Kent Pedestrian Guard Railing Assessment

Sittingbourne – Consultation Report (Version 3)

Project Number B1649000

Illustrated Diagram of site 1

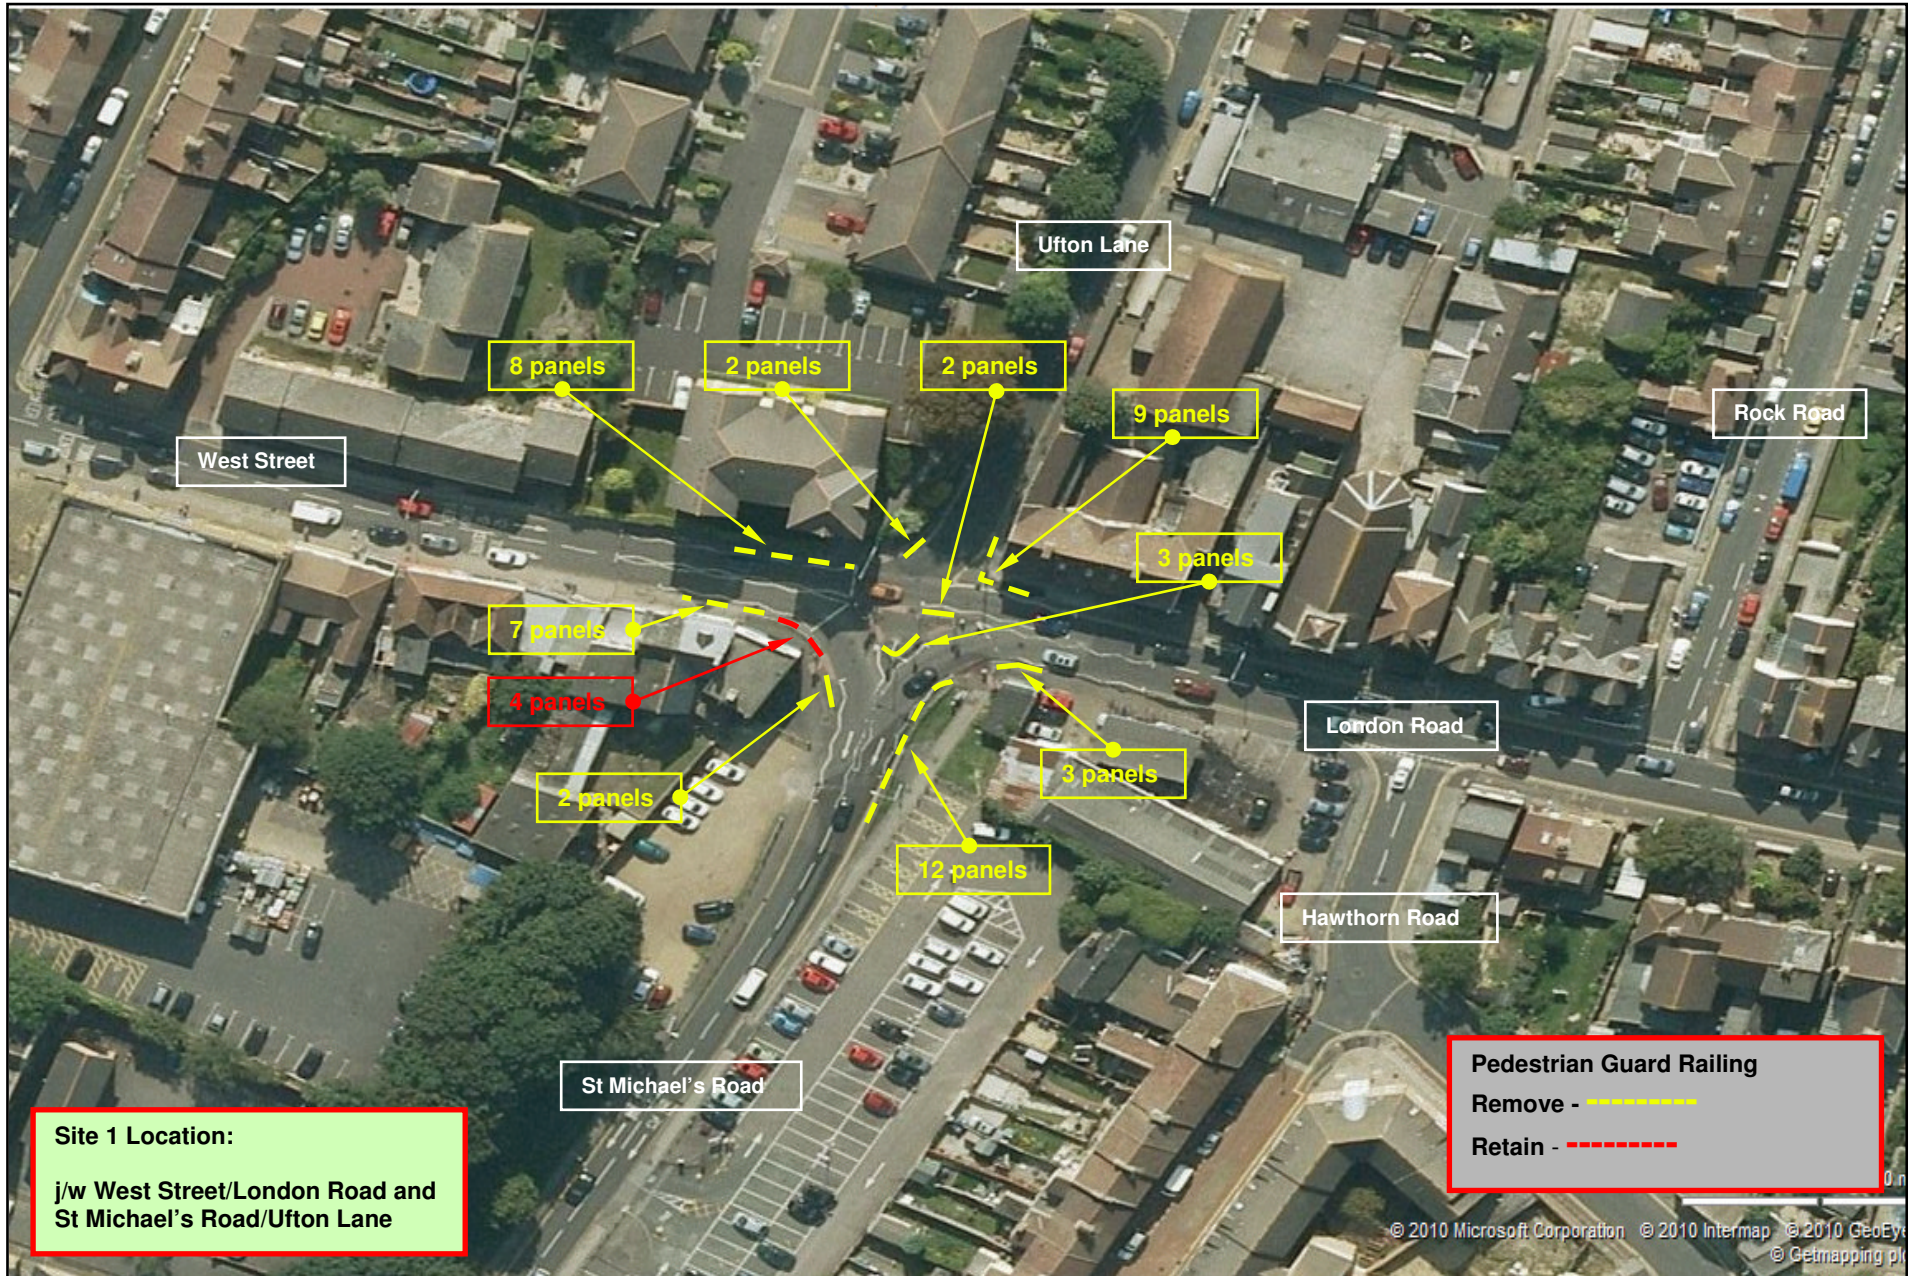
Dropped kerbs with tactile paving will need to be re-located for new desire line.

Pedestrian movements will need to be monitored.

- **It is recommended to partially remove the pedestrian guard railings at site 1.**

Illustrated Diagram of site 3

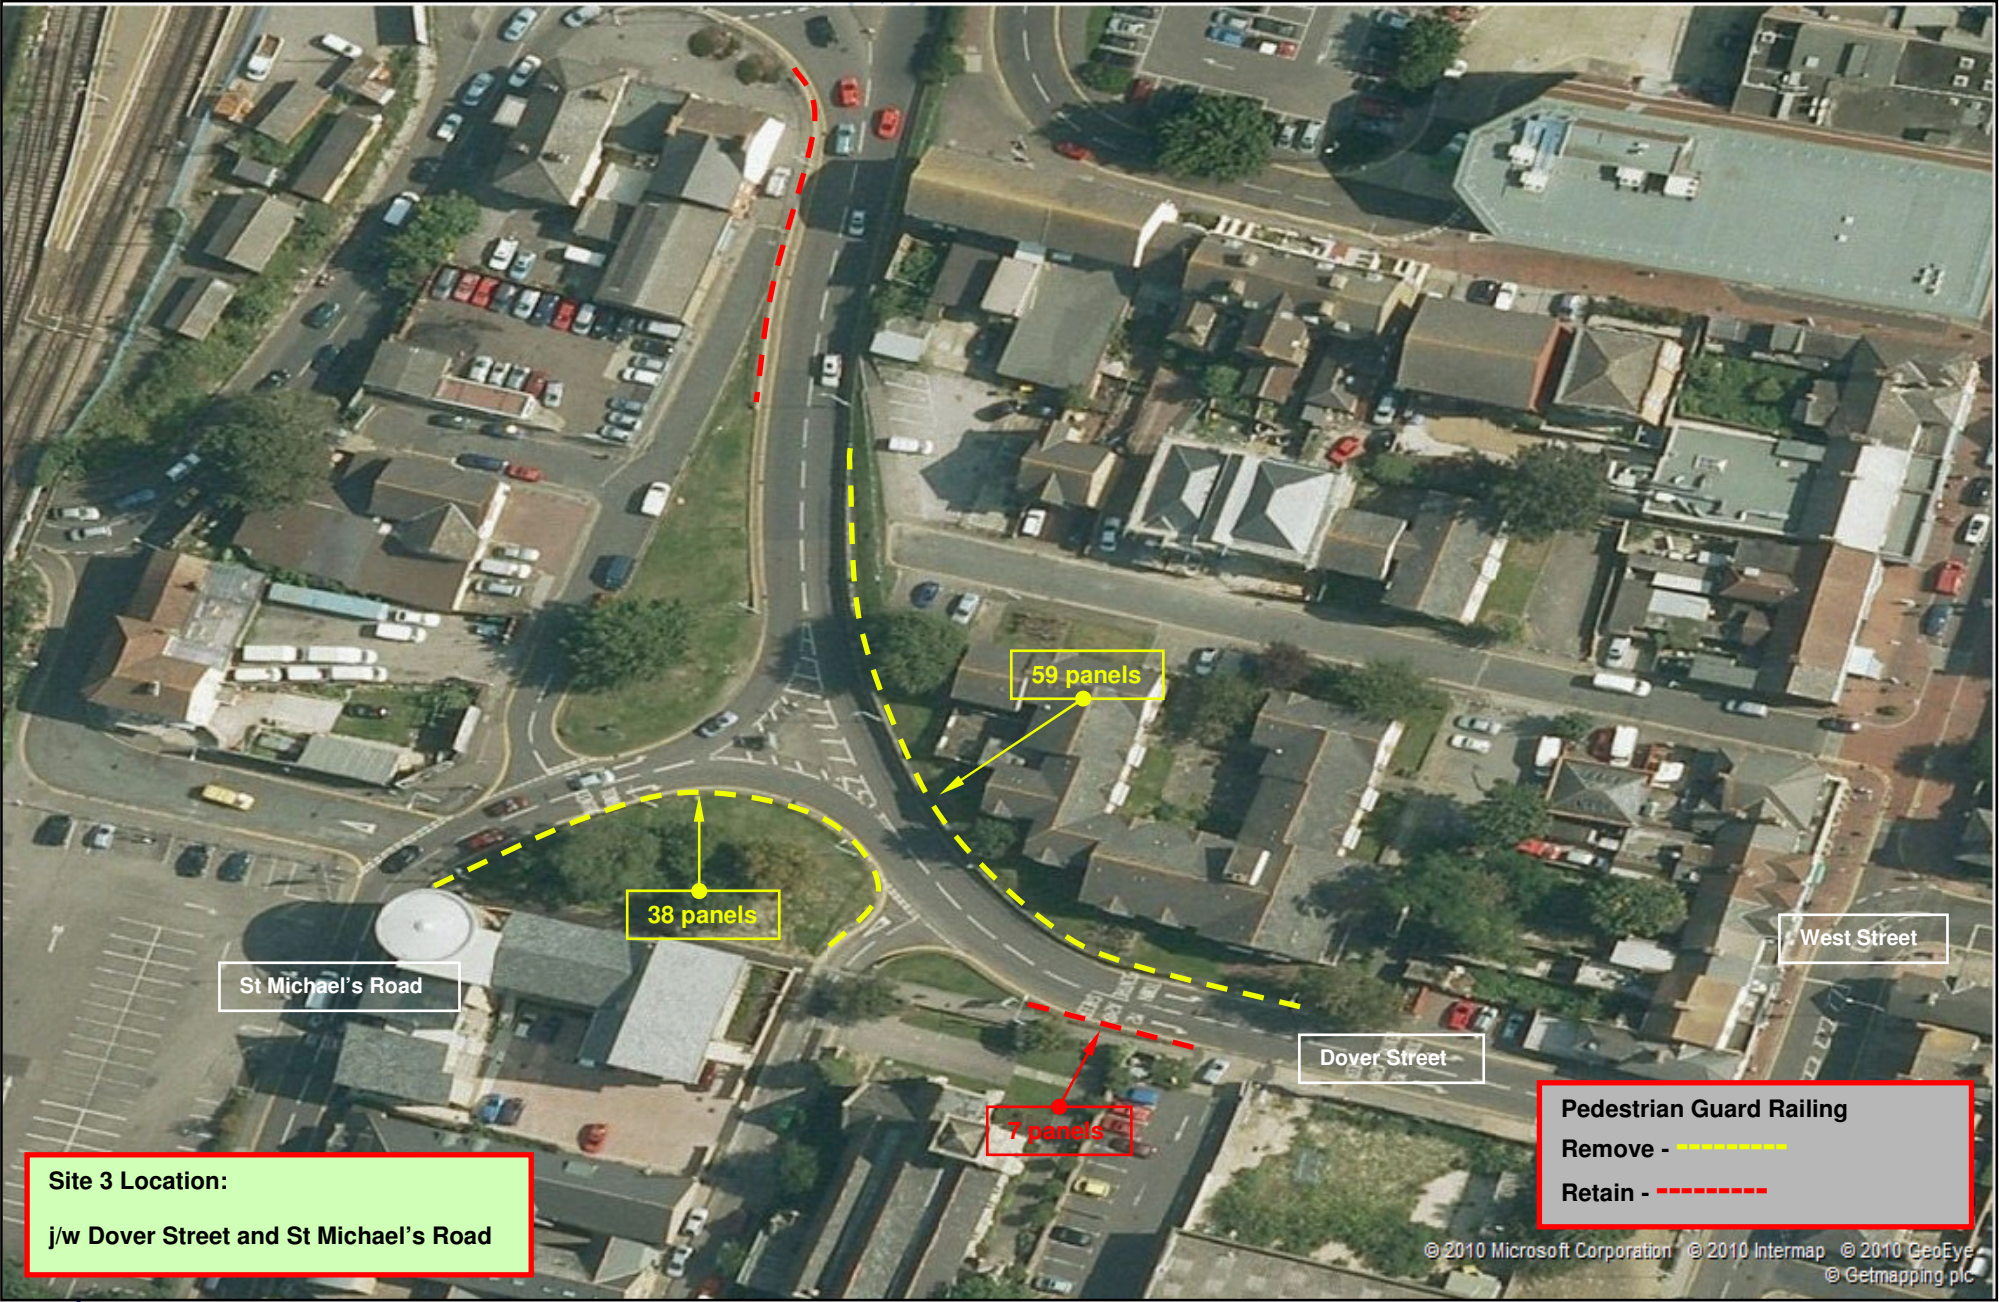
The 7 panels outside Holy Trinity offer protection as there is a difference in levels between the footway and the carriageway.

The site has been reassessed and these panels are recommended to be retained.

- **It is recommended to partially remove the pedestrian guard railings at site 3.**

Illustrated Diagram of site 4

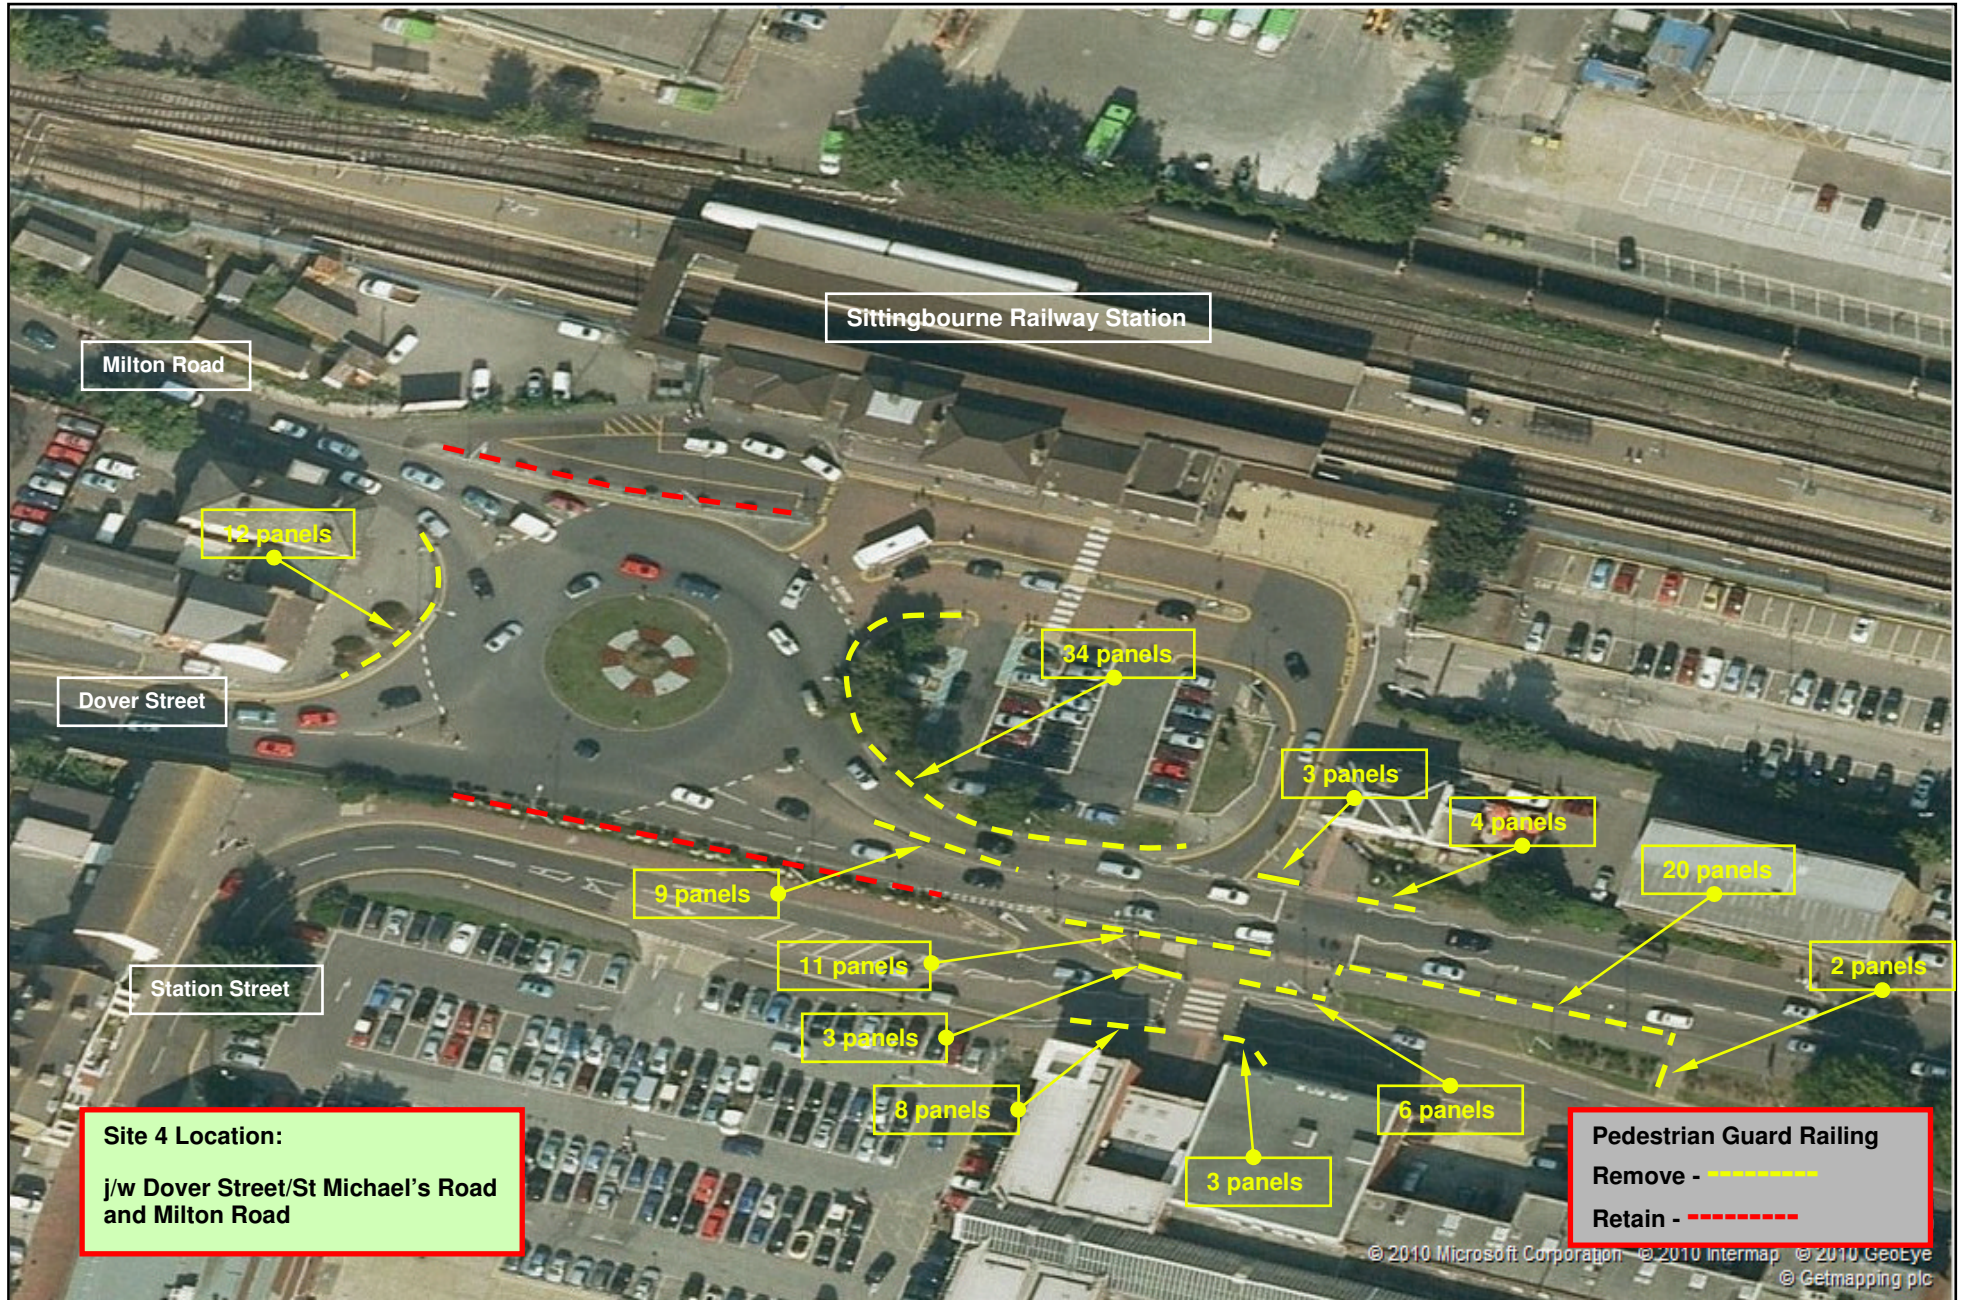
Concern over removals because the area is heavily used by school children.

The railing around the car park is redundant. Sight lines are unobstructed, vital guard railing is to be retained

- **It is recommended to partially remove the pedestrian guard railings at site 4.**

Illustrated Diagram of site 7

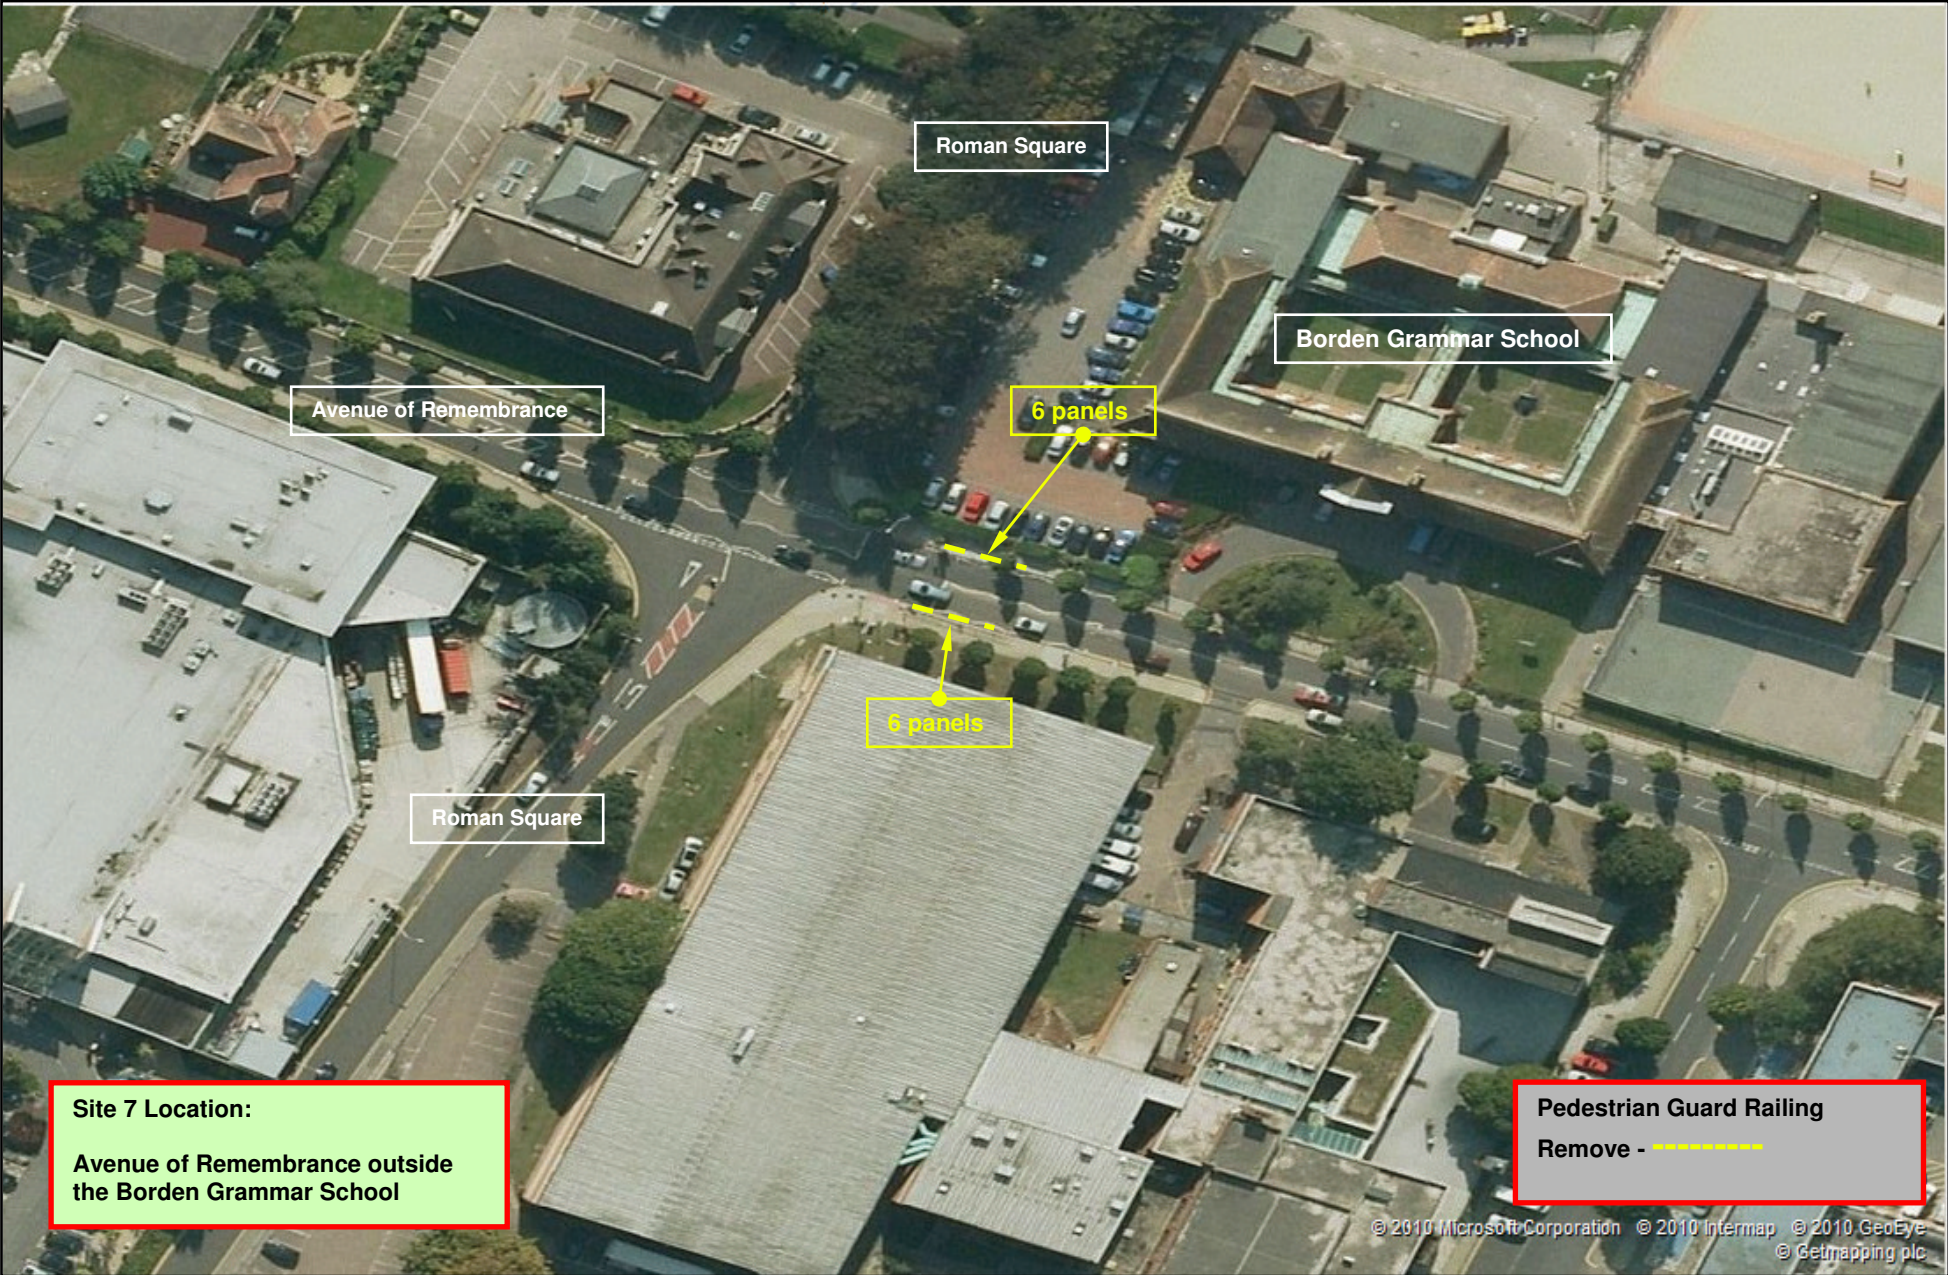
The 6 pedestrian guard railing panels either side of the carriageway offer little benefit as a guide or protective device.

- **It is recommended to remove the pedestrian guard railings at site 7.**
